Proposed Part Elevation facing Northwest - Vivary Cottage

Proposed Rear Area elevation facing southeast adjacent to walkway

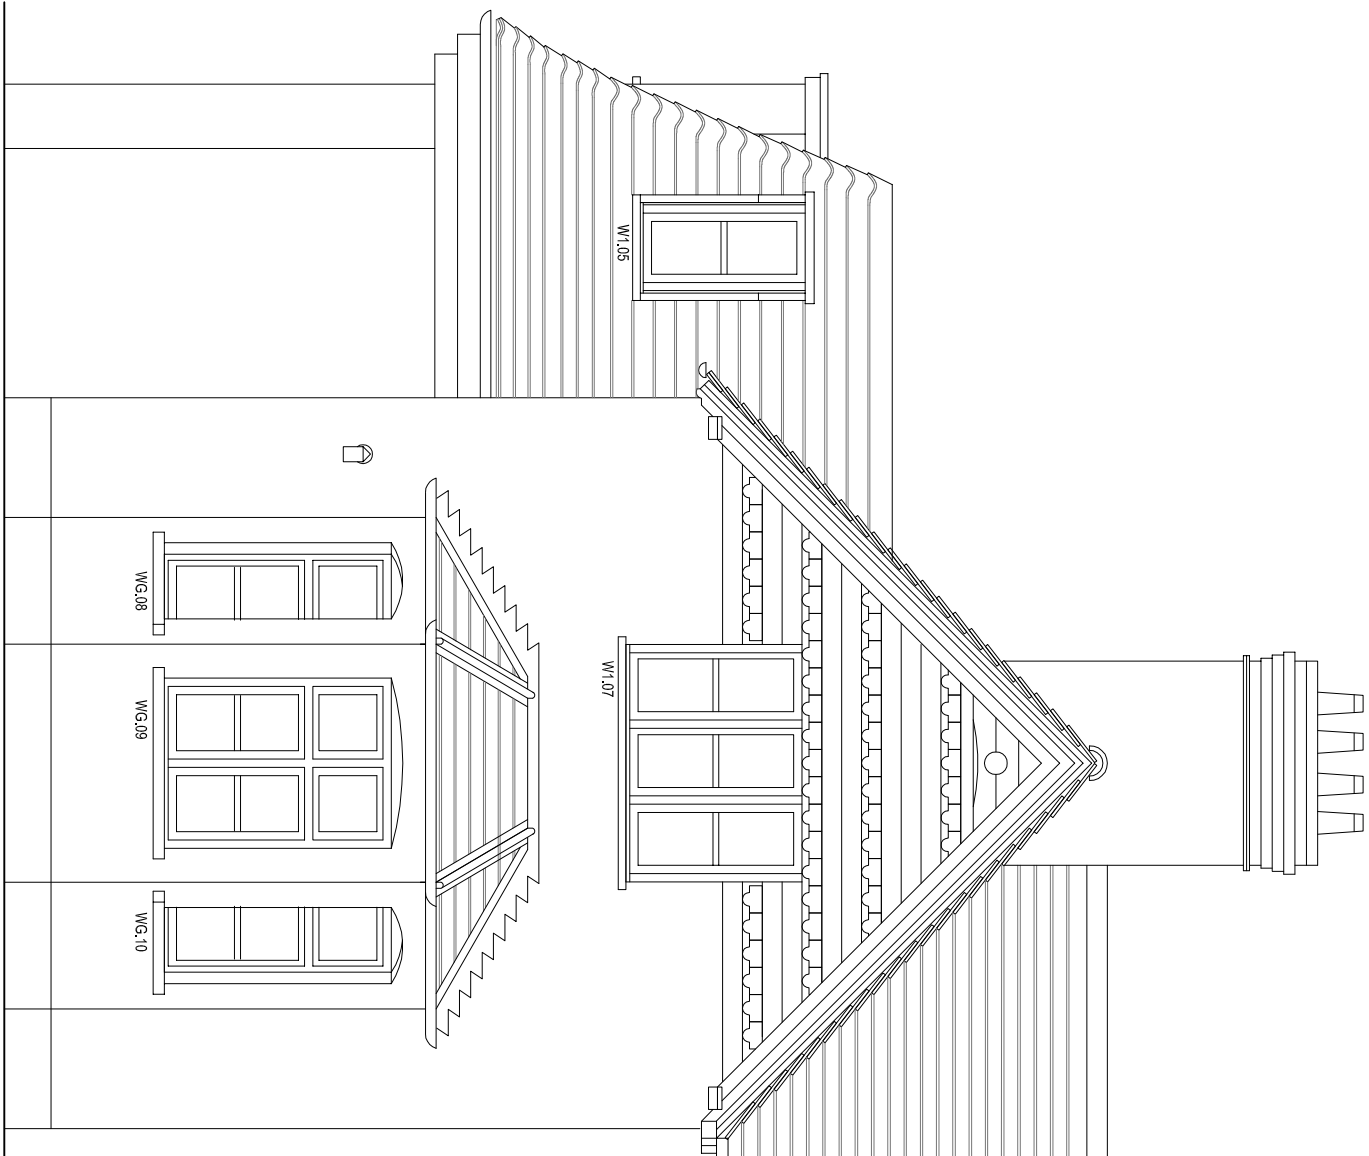
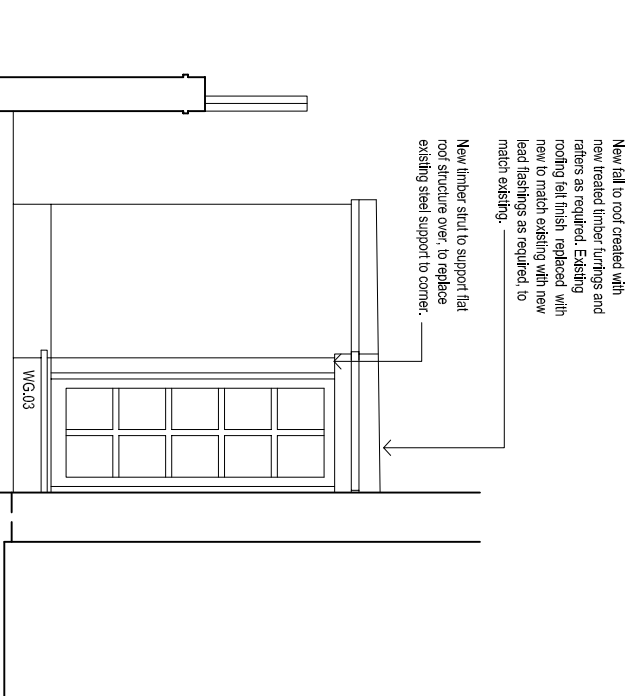
A. Proposed windows to be single glazed. WG.03 altered. 17/04/17

New high performance felt roof finish to rear extension with furrings altered to ensure adequate fall. New single glazed timber window to WG.03 and W1.05 to match detail of existing timber window W1.06 with reveal to accommodate 4mm glazing, see detail PR-D01 and D02.

WG.03 to be obscure glazed with Pilkington Arctic or equal approved.

WG.03 requires new timber strut to support roof timbers to replace existing steel strut at corner.
